11/18/97 120597 12/16/97
SOUTHEASTERN DISTRICT HEALTH DEPARTMENT
69 69 465 MEMORIAL DRIVE
POCATELLO, ID

NAME Koy Rydman		PHONE (Dave Fredrickson) 235-2245	PROPERTY ADDRESS 5295 Buckskin Rd		
MAILING ADDRESS: C/O 1069 Spruce		LEGAL DESCRIPTION: LOT SIZE (ACRES) 0.4			
STREET/R.O. BOX		1/4 SECTION NW 1/4 NE SECTION 26 TOWNSHIP 6S RANGE 35			
CITY Pocatello		LOT # _____ BLOCK # _____ SUBDIVISION _____			
STATE ID		PARCEL # PR Bks 500.3201 FROM TAX ASSESSOR'S OFFICE			
SEPTIC TANK SIZE 1000 gal.	EST TYPE 232	EFFECTIVE DISPOSAL AREA 556 SQ.FT.	SOIL TYPE B2	MAXIMUM DEPTH BELOW GROUND SURFACE 8' 3 in.	# BEDROOMS 3

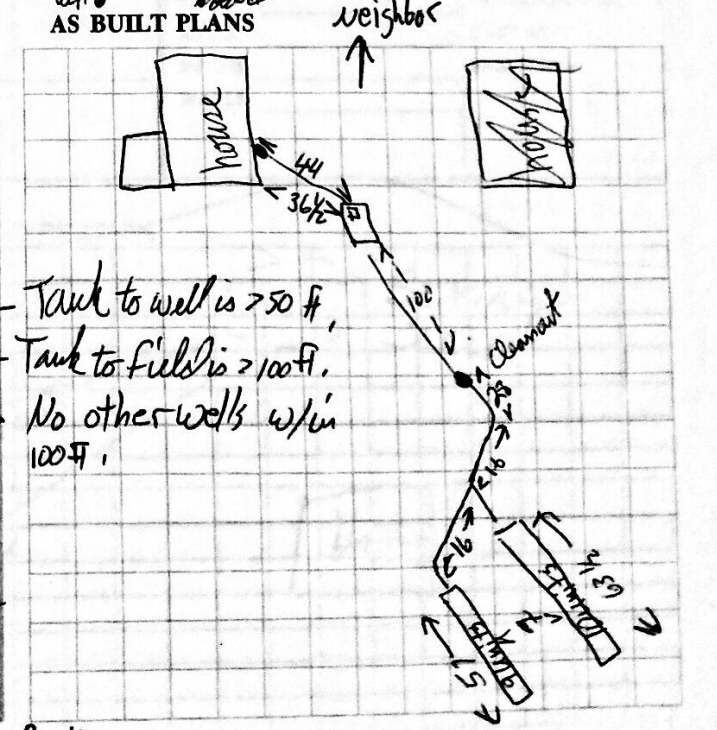
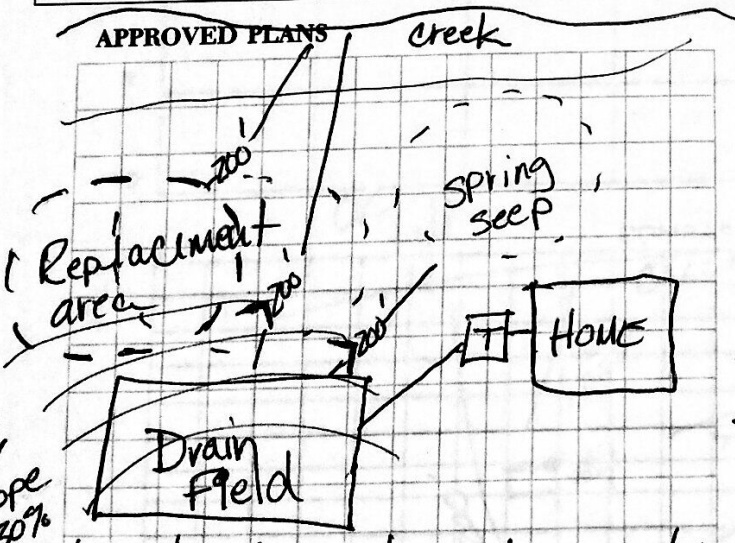
EHS SIGNATURE <i>[Signature]</i>	EHS # 72	APPLICANT SIGNATURE <i>[Signature]</i>	DATE 8-29-97
REMARKS Steep slope system minimum depth 30" to bottom of trench

EHS SIGNATURE <i>[Signature]</i>	DATE 12/16/97	EHS # 69
REMARKS (see yellow page attached 11/18/97 GF) System is changed to Capping fill trench as even moved to 3ft above original trench

initial system is a steep slope system must be put in on hill. Replacement system may be used with provision that a cut-off trench is installed w/ replacement system when initial system fails
